UNITED STATES PATENT AND TRADEMARK OFFICE

APPLICATION NO.	FILING DATE	FIRST NAMED INVENTOR	ATTORNEY DOCKET NO.	CONFIRMATION NO.
10/761,449	01/20/2004	Mark O. Olson	1579	3048
23518	7590	08/22/2006	EXAMINER	
KEY SAFETY SYSTEMS, INC.			DUNN, DAVID R	
PATENT DEPARTMENT			ART UNIT	PAPER NUMBER
7000 NINETEEN MILE ROAD				
STERLING HEIGHTS, MI 48314			3616

Office Action Summary	Application No.	Applicant(s)
	10/761,449	OLSON, MARK O.
	Examiner David Dunn	Art Unit 3616

DETAILED ACTION

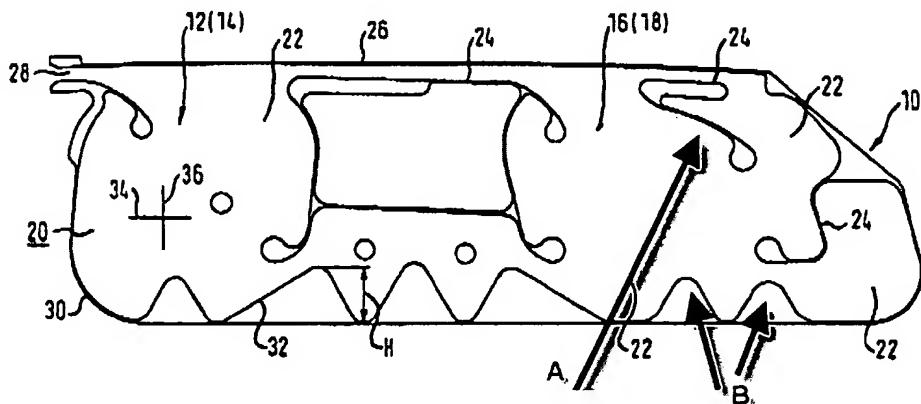
8. Claims 16, 18, 20-24 and 26-31 are rejected under 35 U.S.C. 102(b) as being anticipated by Nusshor (US 2002/0005635).

Nusshor discloses an airbag comprising a first inflatable region (16) including a first set of restrictions (see A in Figure below) and a second set of restrictions (see B in Figure below), wherein the restrictions are off-set from each other. The first set of restrictions also includes the leftmost restriction at the top of the airbag. The joints all include a base, a body and a distal end. The central portion 24 forms a set of joints forming a U-shape (on the bottom of the central portion).
